# Recall Bulletin 160429REV

**PRODUCT(S) AFFECTED:**  
Holiday Rambler Brand Endeavor and Endeavor XE manufactured between 11/17/2015 and 4/7/2016

**SUBJECT:**  
Providing Front Passenger's Side Tire Clearance

**ISSUE DATE:**  
June 2016

Figure 1

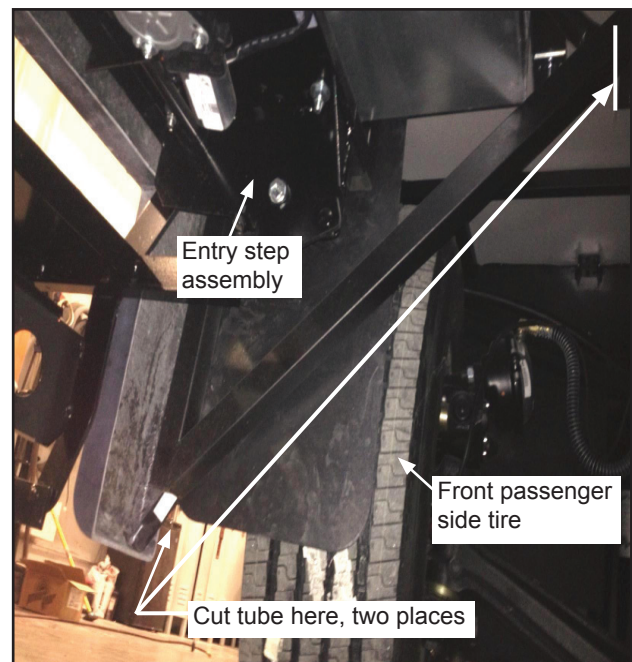
On motor homes affected by this recall, a diagonally-oriented section of tube steel, designed as a support framework component for the fiberglass wheel-well skirt, has the potential to contact the front passenger-side tire, or force the front passenger-side mud flap into contact with the tire.

4. Referring to Figures 1 and 2, locate the angled section of tube forward of the front passenger's side front tire, near the entry step assembly. Use a metal cutting tool to remove this tube. **DO NOT REMOVE ANY COMPONENTS OTHER THAN THE TUBE IDENTIFIED BY THE ARROWS IN FIGURE 2.**

5. Using a pneumatic grinding tool to remove any burrs or sharp edges.
6. Touch up the area with black spray paint.
7. Inspect the front passenger's side mud flap; it may require one or two additional self-tapping screws to properly secure it in position.

8. Remove the jack stands and lower the vehicle.
9. Have an assistant turns the steering wheel from side to side. Observe the front passenger's side tire to ensure it does not make contact with anything. Correct if necessary.
